NASA/TM-2010-216870 NESC-RP-10-00635

Independent Peer Review of Communications, Navigation, and Networking re-Configurable Testbed (CoNNeCT) Project Antenna Pointing Subsystem (APS) Integrated Gimbal Assembly (IGA) Structural Analysis

NASA Engineering and Safety Center Technical Assessment Report	Document #: NESC-RP- 10-00635	Version: 1.0
Title: Independent Review of CoNNeCT Antenna IGA Model and Analysis		Page #: 1 of 57

Appendix A. APS Model Review, July 21, 2010

Figure 6.1-6. Gimbal Actuator Capacity (excluding Torsion Limit)

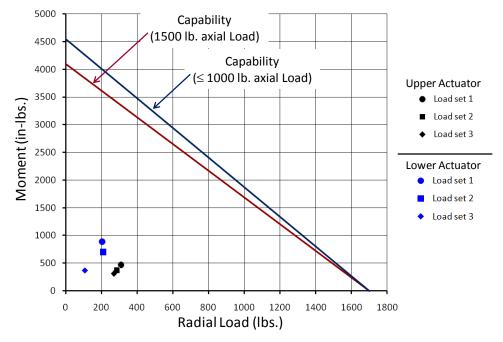
The other forces and moments in the actuators were compared to capability in Figure 6.1-6. In this figure, radial load is plotted against the moment. The two straight lines represent the failure boundary that is determined by the combination of axial, radial, and moment loads on the main bearings so as to not affect actuator life. Hence these lines represent the capability limit for that particular value of the axial load in the actuator. The upper line corresponds to a capability limit for an axial load less than or equal to 1,000 pounds (lbs). The lower line corresponds to an axial load of 1,500 lbs. If the axial load is greater than 1,500 lbs, then the actuator will have a negative MOS on some component (probably a bearing).

All points below the lines in this figure represent combinations of radial loads and moments for safe operations (i.e., positive MOS). The root mean square (RMS) values for the radial loads and corresponding moments shown in Table 6.1-2 are plotted on Figure 6.1-6 with black symbols for the upper actuator and blue symbols for the lower actuator. From this figure, there is significant positive MOS for these actuators for a 1,500 lbs axial load capability.

TRIA3 Elements

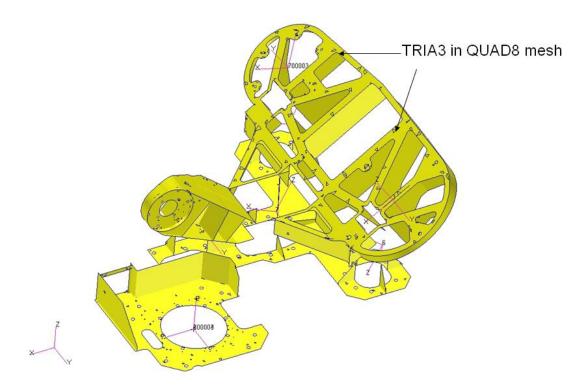
- There are large areas modeled with QUAD8 elements with TRIA3 elements imbedded in these areas. I would have expected TRIA6 elements so as to be compatible with the QUAD8 elements. Free edge check identifies all of these triangular element boundaries.

- SNC is aware of these modeling issues. Apparently, this situation occurred when a local area of the mesh was updated after the majority of the mesh is completed. In the next model revision, all Quad 4 and Tria 3 will be updated to Quad 8 and Tria 6 elements with proper connectivity.

Mesh Not Connected

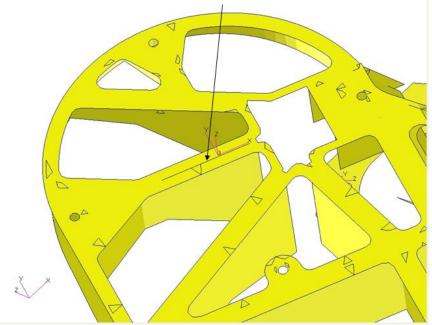
- 3. There are what appear to be gussets or stiffeners plates under the baseplate are where the meshes do not line up so there is no connectivity between the baseplate and the stiffener in that area.

- SNC will examine this region to determine if there is a connectivity issue in those local areas. The modal analysis will then be updated and the results scrutinized.

Rigid Element on Baseplate

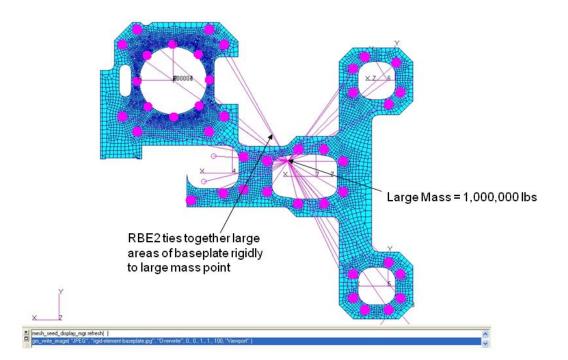
- 4. There is a large RBE2 (rigid element) on the baseplate which attaches all the bolt holes to a central point where a large mass is located. This effectively ties these holes together rigidly. So when free-free modes are run as stated in the PowerPoint slides you will get the effect of this rigidization of the baseplate. Not sure if that is what is desired or not. This appears to be in the model to support the old "large mass" method of inducing base acceleration. Newer versions of NASTRAN have allowed you to directly input applied acceleration without having to use the large mass method.

- SNC: The "large mass" method is a widely accepted and historically used method of performing random response analysis. This method is typically used by SNC.

- SNC: The RBE2 constraints on the nodes on the base plate to connect to the node where the mass is located will rigidize the base plate. In reality the base plate is effectively rigid along that interface due to the large number of 0.250-28 fasteners used to secure the base plate.

- SNC: In the free-free mode analyses the RBE2 constraints would tie the plate together and may miss some "free" elements. Therefore, SNC performed the freefree analyses again to demonstrate that no "free" elements exist and that the previous free-free modes analysis is valid. (See Appendix A).
